APPROVED MINUTES OF THE MEETING

January 21, 2010

Project: Alaskan Way Viaduct Seawall Replacement

Project: Fire Station 9 - Fremont

Figure 1: North Portal Options 1 and 2

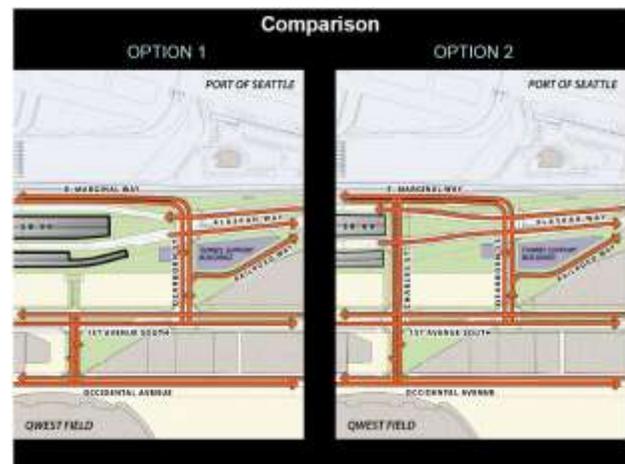
- There is concern about the quality of the pedestrian promenade proposed to be located in the footprint of the viaduct ramps along Railroad Way (running diagonally between Alaskan Way and 1st Ave S) because it is pinched at First and S. Dearborn St. Considering the volumes of pedestrians and the potential for views between the stadiums and the waterfront, please consider how this pinch point might be remedied. Addressing this problem will also help maximize the open space potential by better linking the plazas proposed on both sides of S. Dearborn St.

- Consider how clarity in design of the highway and ramps can reduce the need for signage. At the north portal there are some counterintuitive elements in the access that need to be addressed.

In the north portal area, how will pedestrians go north across Aurora?

Lots of our comments pertain to details that go beyond today's presentation. Concerning the north portal, one of the tools that can be used to slow traffic is a circuitous approach. Look for opportunities at the south portal to decompress people in a geometric fashion. More acknowledgement and awareness of signage will be helpful in the future.

Pedestrian connections will be on both sides of 6th Ave to the north of the entry ramp only. Pedestrians looking to cross over Aurora will have to cross at one of the streets south of the tunnel entrance. The entrance and exits in the vicinity will not allow for pedestrian crossings due to the elevation changes. Aurora width is 92-feet wide and becomes wider. We have not finalized this design. We would like to maintain 14-foot sidewalk widths throughout.

Figure 3: North and South Tunnel Support Buildings

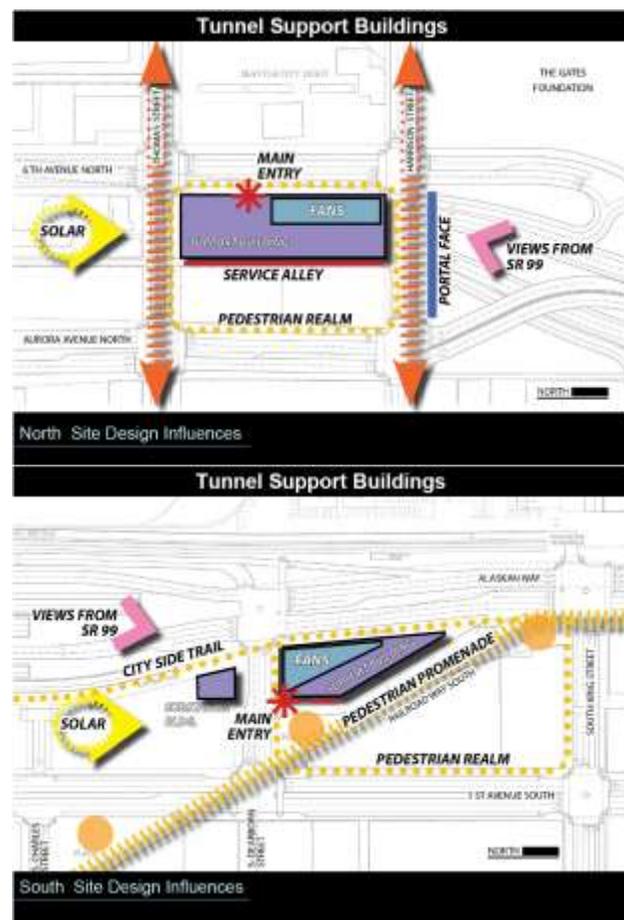
Both the north and south entrances have a portion of cut and cover?

Yes. At the north end, most of the cut and cover portion will be covered by the maintenance building. The south end will include a full block of exposed cut and cover.

Figure 4: South Portal Area Overview Sketch

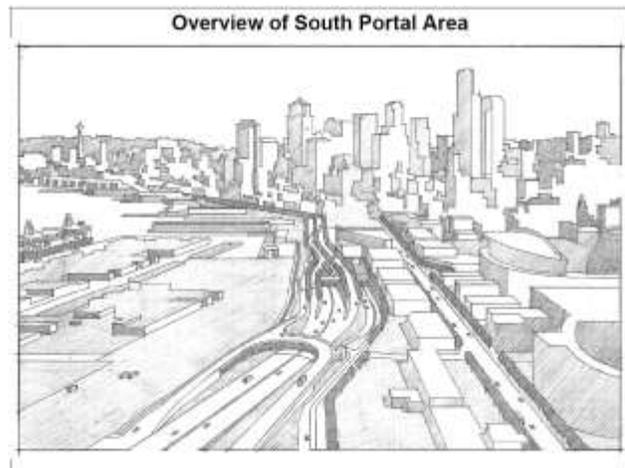
- The stairway on the “little H” overpass that links pedestrians to the rest of the south portal is considered essential by the Commission. This element provides a unique design opportunity for a larger gesture.

Is the U-overpass always open? Are you looking at this overpass as an integral part of the portal expression?

The nature of the edge of the overpass will need to be addressed. I think the way the stair is created, the columns and how they're organized, will all be important aspects. We have three principle elements this corridor, the ramps and entrance, the overpass, and this element. The team has not gotten that far to speak to it.

On the Little H, (overpass) concerning the stairway, I think this is important to keep.

It is always open. It serves two purposes. The bypass and tail track as well as its use as an alternative route.
